SUBMISSION TO INLAND RAIL NARROMINE TO NARRABRI.

Biodiversity development assessment report – BAM 2020 Revision E

Fig 1.

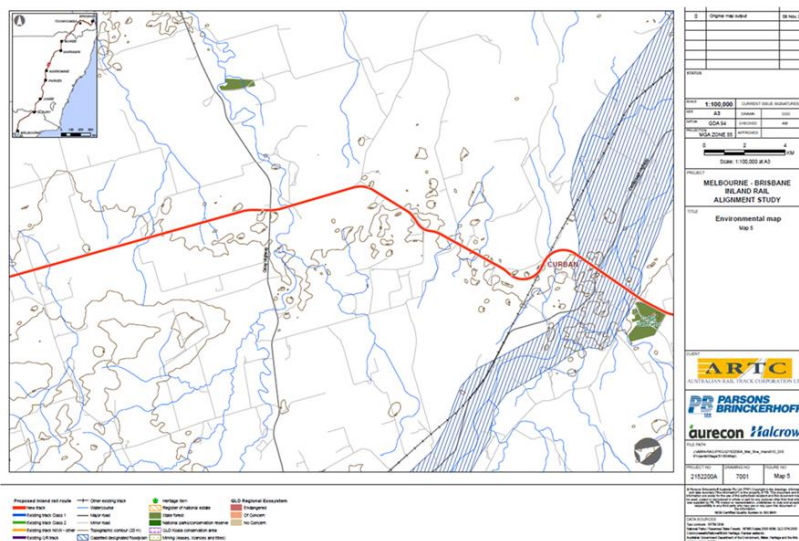
1. The flood mapping in the 2010 IRAS (fig1 below) was taken by ARTC from the Gazetted Castlereagh River flood plan. This plan cites the flood plain to be 4km at the IR crossing point. ARTC’s statement that their “*detailed investigations and modelling*” supersedes the gazetted plan is presumptuous and inappropriate. It is alarming that ARTC would discard a gazetted flood map which shows a 4km flood width for their 805m wide 1% AEP model without any referenced analysis or explanation. The gazetted flood scenario should be taken as the default flood risk and the precautionary principle applied until ARTC categorically proves their new 1% event is a valid replacement. Until then, 4km of bridging is required to ensure environmental, property and public safety concerns are address.
